# Recall Bulletin 140615ARG

**RECALL  
BULLETIN:  
140615ARG**

2015 American Eagle,  
American Revolution,  
American Tradition

**SUBJECT:**  
Inspection/  
correction of seat  
belt mounting  
hardware

Figure 1

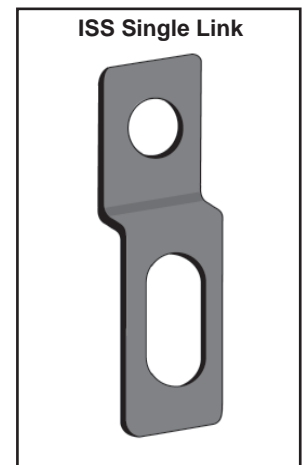
1. Park the motor home on level pavement. Place the transmission in Neutral and set the parking brake. Turn off the key and remove it from the ignition. Maintain control of keys until all repairs are performed.
2. Inspect both the pilot (driver) seat and co-pilot (passenger) seat:
  - a. Locate the seat belt mounting assembly attached to the seat.
  - b. Refer to Figure 1 and the inspection diagram supplied by Villa (Fig. 2 on Page 2) to determine whether or not the seat belt assembly is attached to the seat base by an ISS Single Link.
    - If the seat belt assembly is attached to the seat base by an ISS Single Link, proceed to Page 3, "Seat Belt Attachment Correction."
    - If the seat belt assembly is attached by a different hardware configuration, the seat is not part of the recall and no further action is required.

**Figure 2**

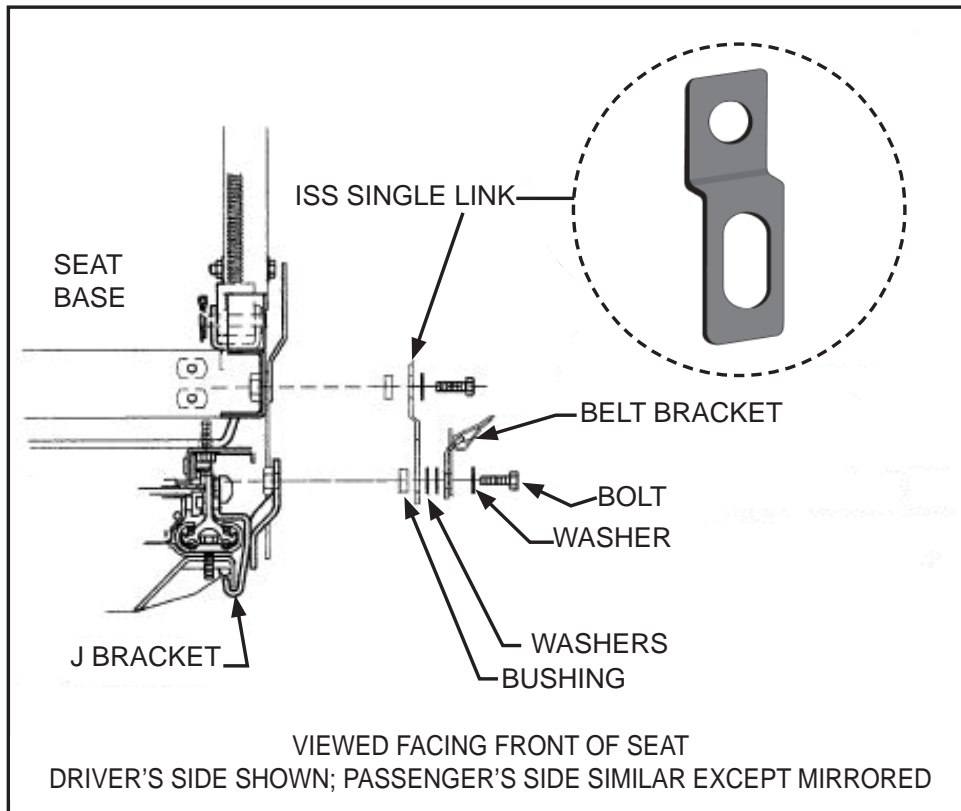
*If the seat belt is attached with an ISS single link, shown above, proceed to the Repair Instructions on Page 3.*

Figure 3

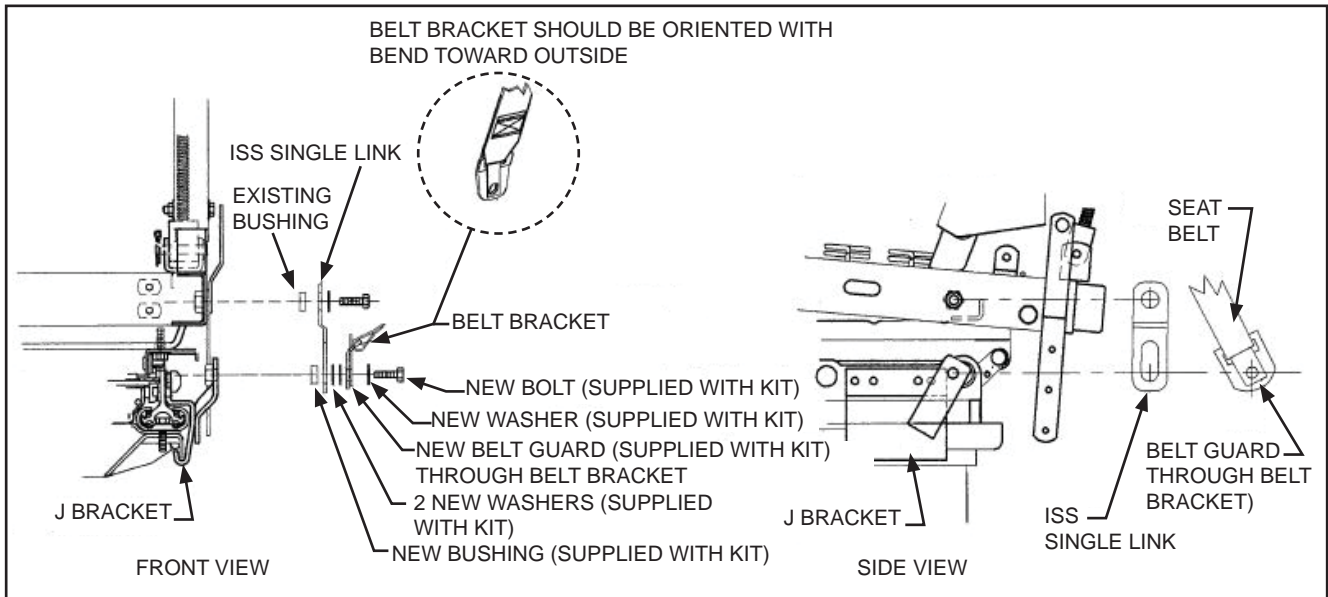
1. Remove the hardware fastening the seat belt to the seat base assembly. Discard the original bolt, washers, and bushing.
2. Insert the new plastic belt guard, included with the recall kit, through the belt attachment bracket as shown in Figures, 3,4 and 5.

- Referring to the installation diagram in Figure 3 and the photos in Figures 4 and 5, reinstall the seat belt through the original ISS single link and to the seat base, using the new washers, bolts, and spacer bushings supplied with the recall kit. Ensure the assembly order is correct. Torque the attachment bolts to 20 ft-lbs.

- Hand-start the bolts to avoid cross-threading.
  - An extra bushing is supplied with the recall kit. Use it behind the top portion of the ISS single link, as shown in Figure 3, if one was not originally installed.
- Verify the seat belt is installed correctly and operates properly; correct as necessary. Reference photos of a completed installation appear in Figures 6 & 7.
  - Repeat steps 1-4 for the opposite seat if required.
